MCHS-300 Dimension Change Notification

MCHS-300

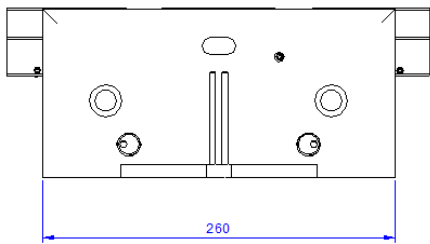
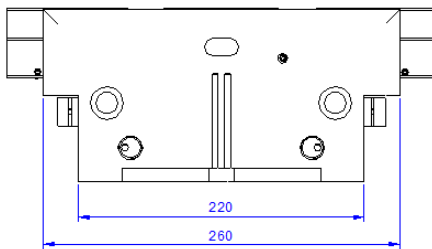
Before	After
The top edge of housing is chamfer. 	The top edge of housing is round. 
The shape of housing is rectangular. 	The shape of housing is T block.
